Technical Bulletin

C521BEE

Hardware Technical Bulletin:C521BEE-H2005-04

Subject: Laser ribbon cable

Figure 1

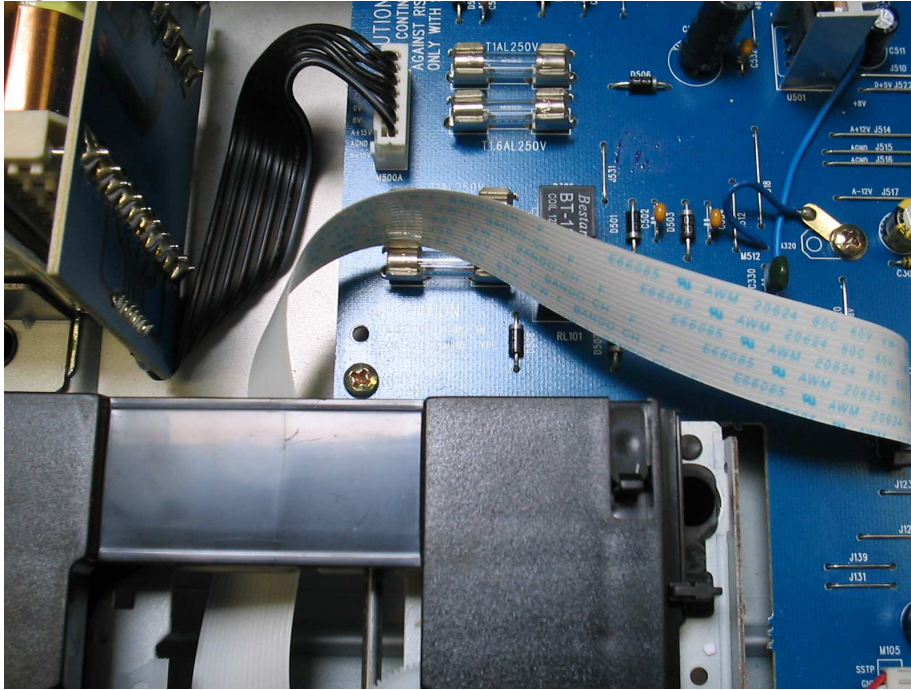
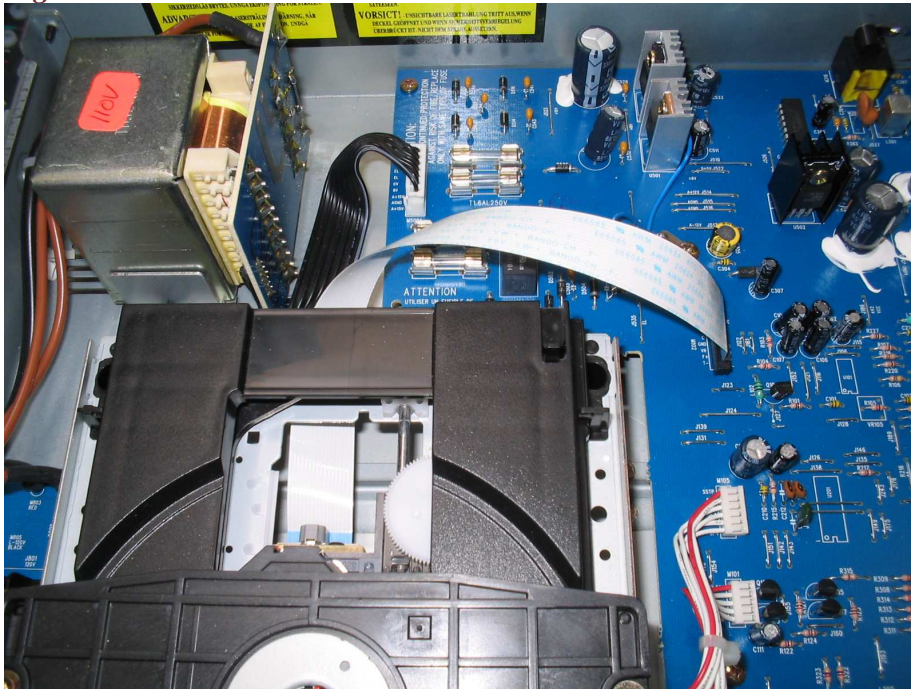
DESCRIPTION: You may have the complaint that some tracks skip or stops playing altogether.

REASON: The laser pick up connects to the main pc board via a flat ribbon cable and possibly is twisted the wrong way . It maybe getting caught on the fuse holders or other parts. just behind the transport mechanism . See figure 1.

SOLUTION: The ribbon cable needs to be allowed to wrap smoothly as shown in figure 2.
